# Access Compliance Report

### (Curb Ramps)

Intersection ID: 54709	Main Street: MARY_BUTLER_WY	Cross Street: OLD_PROVIDENCE_RD	Location: SE
ADA ID: 1FDB4B4D3317	Ramp Type: Perp	Initial Pass/Fail: Fail	Overall Compliance: No
		Severity Score: 12.5

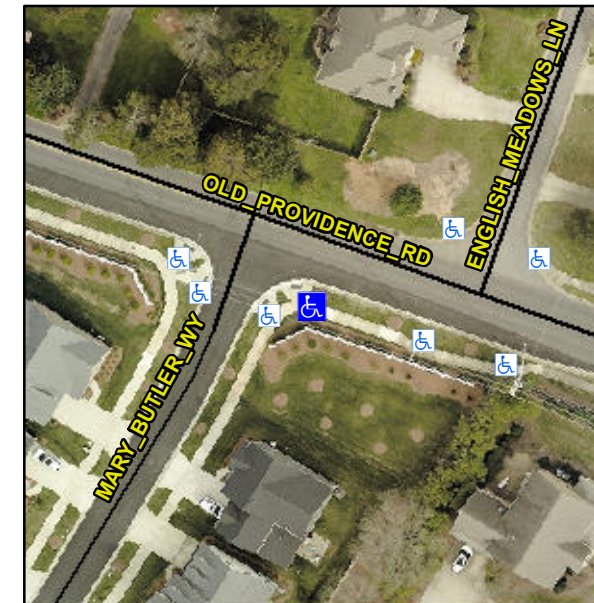
**R304.5.3**

Compliance	Description	Data	Compliance	Description	Data
N/A	Ramp Length (in)	96.0	Yes	Ramp Slope (%)	6.7
Yes	Ramp Width (in)	71.0	No	Ramp XSlope (%)	5.2
N/A	Flare Type LT	N/A	N/A	Flare Type RT	N/A
N/A	Flare Slope LT (%)	N/A	N/A	Flare Slope RT (%)	N/A
N/A	Flare Traversable LT?	N/A	N/A	Flare Traversable RT?	N/A
N/A	Landing Length (in)	N/A	N/A	DWS Provided?	N/A
N/A	Landing Width (in)	N/A	N/A	DWS Contrast?	N/A
N/A	Landing Slope (%)	N/A	N/A	DWS Length (in)	N/A
N/A	Landing X Slope (%)	N/A	N/A	DWS Full Width?	N/A
N/A	Landing Curb? (Y/N)	N/A	N/A	DWS Offset (in)	N/A
N/A	Shared Landing?	N/A			
N/A	Gutter Ponding?	N/A	N/A	Gutter Slope (%)	N/A
N/A	Gutter Lip Ht (in)	N/A	N/A	Gutter X Slope (%)	N/A
N/A	Painted X Walk1?	No	N/A	Painted X Walk2?	N/A
	X Walk 1 Direction	To NE		X Walk 2 Direction	N/A
N/A	X Walk 1 Width (in)	N/A	N/A	X Walk 2 Width (in)	N/A
	X Walk 1 Slope (%)	3.1		X Walk 2 Slope (%)	N/A
	X Walk 1 X Slope (%)	0.1		X Walk 2 X Slope (%)	N/A

**Remove & Replace Entire Ramp.**
